Town of Yountville

Zoning and Design Review Board Staff Report

ADDRESS: 36 Ivy Court

Adopt Resolution Number 25-022 conditionally approving Design Review for remodeling and expansion of a single-family residence, construction of auxiliary structures and new landscaping, and a Tree Removal Permit for the removal of two (2) protected trees at 36 Ivy Court and finding the project exempt from the California Environmental Quality Act (CEQA).

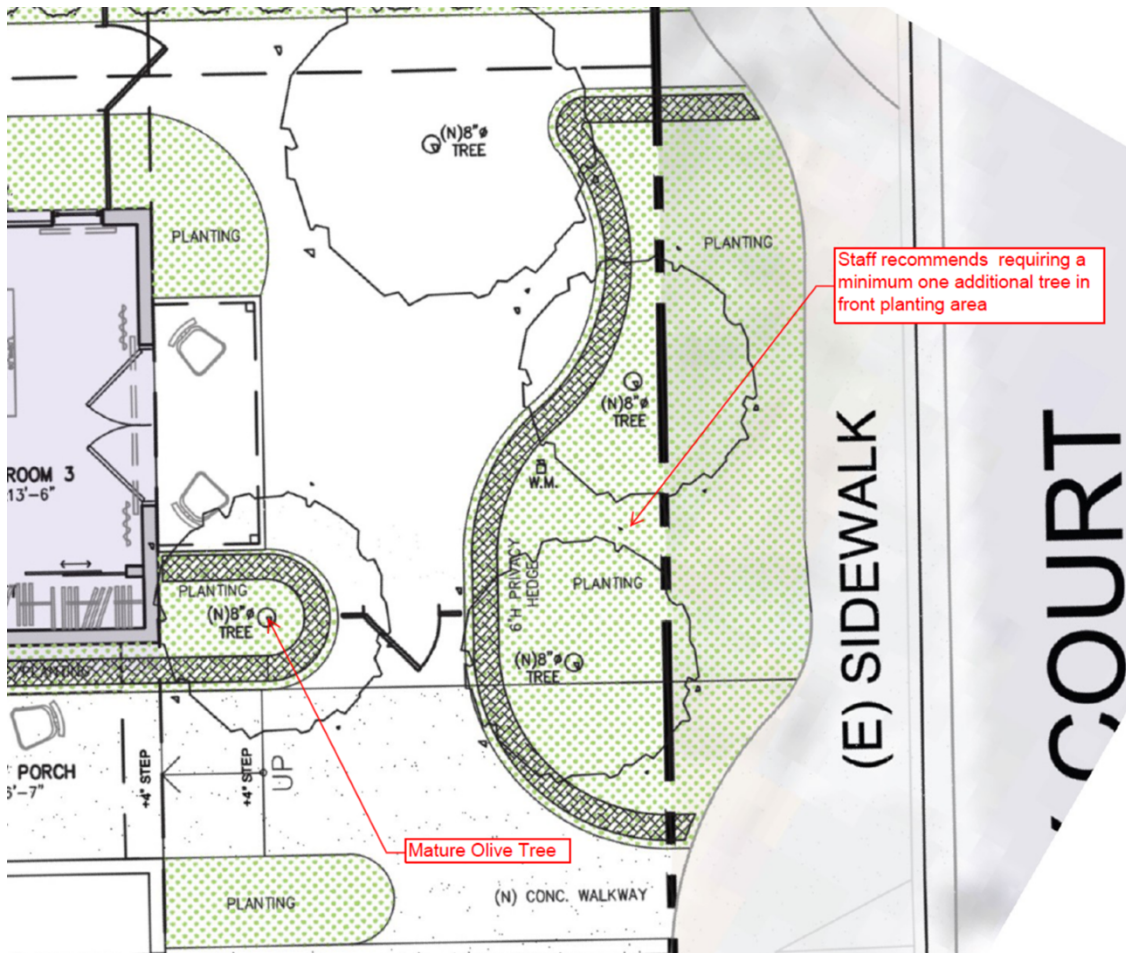
The Design Standard for new structures require garages to be set back 10-feet from the front facade of the house. Additional Design Guidelines discourage garages near the front of the lot. The current structure does not conform to this standard as the front facade of the home is currently set back approximately 4-feet from the garage.

The project proposes to maintain the garage in its existing location, with the eastern (front) facade at the 20-foot setback. Staff discussed these Design Standards and Guidelines with the Applicant and how to address these given the existing condition/location of the garage. In response, the Applicant revised the proposed design to bring the northern wall of the front facade ("Bedroom 3") forward to the same 20-foot front setback line, and added a new covered porch set 4-feet three inches into the front yard setback (an allowed encroachment).

The project as proposed will improve on the existing condition by bringing the front facade of the home up to the setback (20-feet, in line with the existing garage) and providing a covered porch which extends 4-feet 3-inches into the front facade (up to eight feet is allowed by YMC §17.108.010(B)). While the location of the existing

garage is not being modified, these proposed elements will minimize the prominence of the existing garage in relation to the house and provide just over a four-foot setback from the house structure.

Given the location of the garage at the front setback line is an existing condition, and that the project is improving the design by bringing the house facade to the setback (the maximum allowed by code) and providing a porch beyond that in the front yard, staff believes this deviation from the standard is supportable.

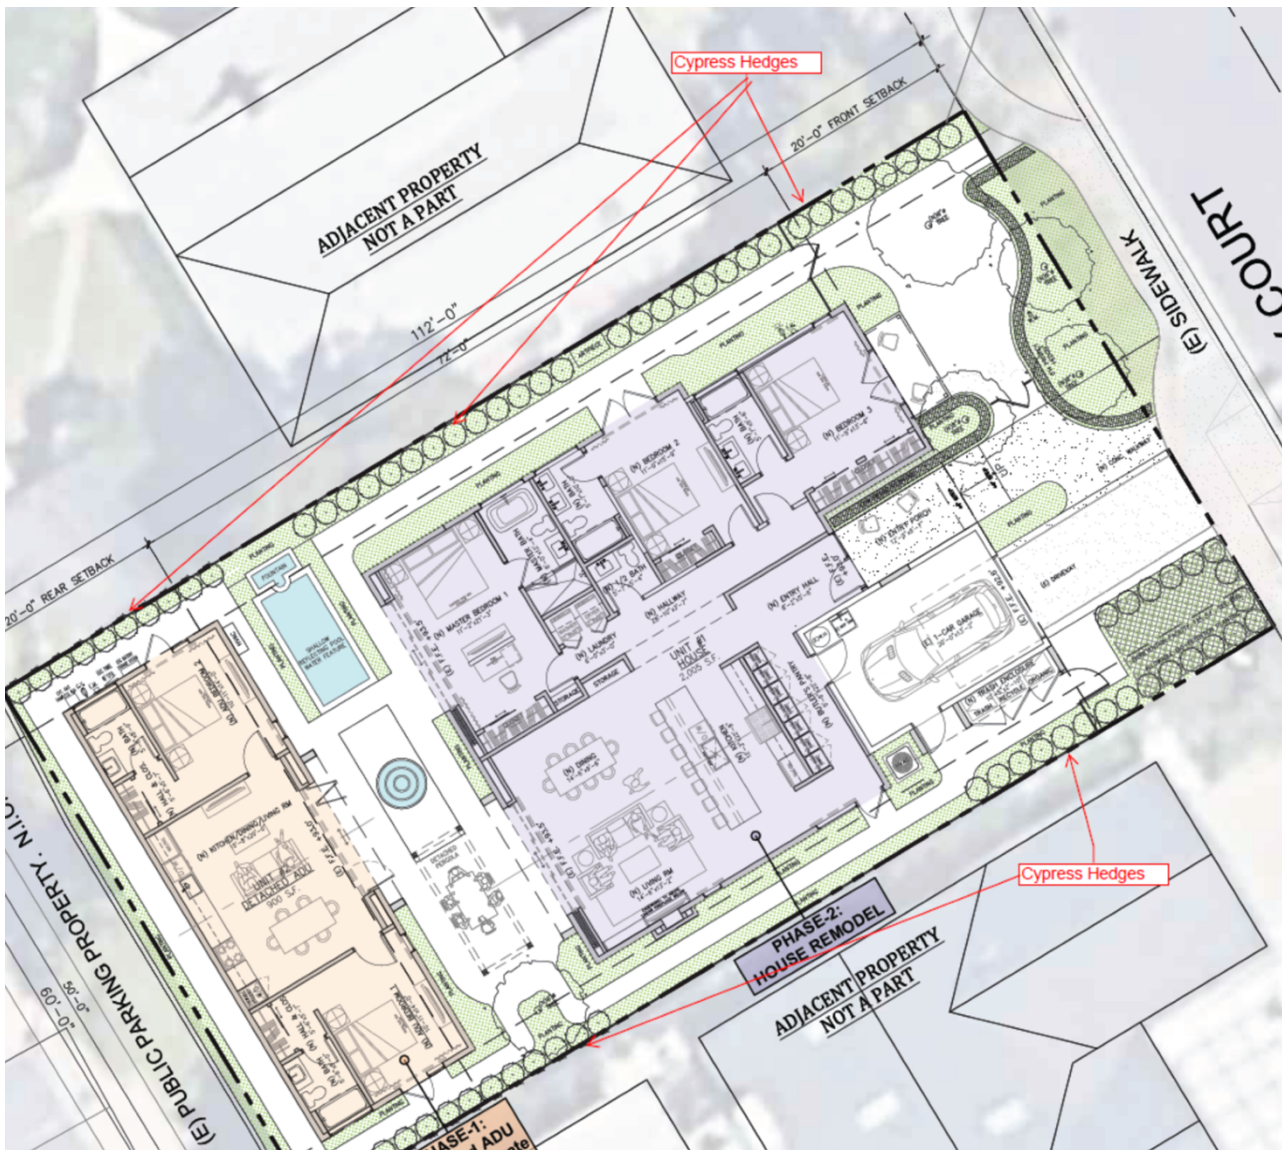
The project proposes four trees in the front yard north of the driveway to meet the Residential Design Standard for Landscaping and Open Space, which requires a minimum of one tree in the front yard (per YMC §17.40.020), and to provide replacement trees as mitigation for the proposed tree removal (per YMC §17.128.070). One of these trees, closest to the front door, is identified as a mature olive tree. The other trees are not yet identified.

Staff have concerns regarding the practicality of fitting four larger trees into this area given the proposed underground utility locations. While one tree is identified as a mature olive tree (near the front entry porch), the other three trees are not yet defined. Staff are therefore recommending a condition of approval requiring a minimum of one 15-gallon tree be planted in the front yard in addition to the olive tree near the porch to ensure the project adheres to the Design Standards.

The landscape proposes to plant Italian cypress hedges along both the north and south property lines in addition to the 6-foot privacy fencing, with breaks in the hedges on the north side at the side door to the bedroom and at the fountain in the rear yard, and on the south property line at the wall of the residence. The plant species proposed is Italian cypress, a tall thin linear hedge planting (see last page of Attachment 3 - Plan Set). Staff has concerns that the full-height variety of these trees, with a mature height of 60-70 feet (typical height 35-40 feet) and planted as an almost continuous hedge would block an enormous amount of natural light for the property to the north and would be out of scale with the single-story residences.

Staff is recommending that the cypress hedges be restricted to a variety of cypress trees with a maximum height of 20-feet (requiring this for both north and south hedges would address the issue of the scale of the trees to the structures). The ZDRB should review this landscape element and provide direction regarding landscape impacts to the adjoining property, as there are varieties of Italian cypress that have a maximum height of 8-10 feet, 15-20 feet, and the full scale (35-60 feet) which could be required as a condition of approval.
